**Consultation Response from KC,
Highways Development Management**

2025/90891 Land at, Yew Tree Road, Birchcliffe, Huddersfield, HD2 2EQ

Variation of conditions 1 (Plans), 2 (Materials), 6 (Landscaping), 7 (Landscape Management Plan), 14 (Ecological Design Strategy) on previous permission 2021/91933 for reserved matters application pursuant to outline permission 2018/90776 for erection of 10 dwellings

Date Responded: 14-7-2025

Refuse lorry - East to west

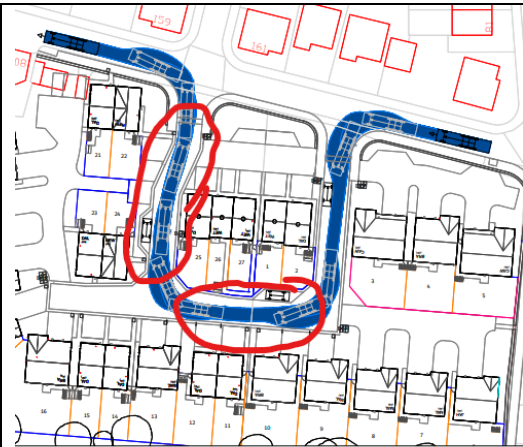
Kirklees require a swept path analysis for an 11.85m in length refuse vehicle indicating how it can pass an on-coming or parked family car throughout the layout. The carriageway will require widening on the bends to enable this manoeuvre. The refuge lorry below does not indicate how it can pass an on-coming car in the areas circled red below which is not acceptable and hence the carriageway will require widening.

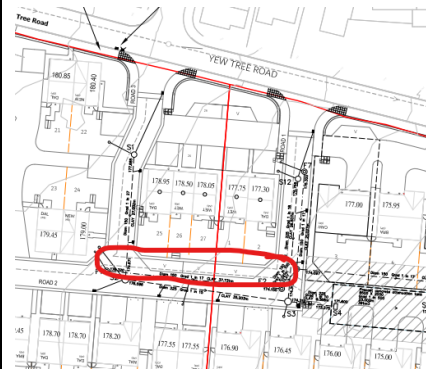
The RSA Brief lists a drawing which is not consistent with the latest design and hence this will need to be updated and resubmitted before approval of the RSA Brief can be granted.
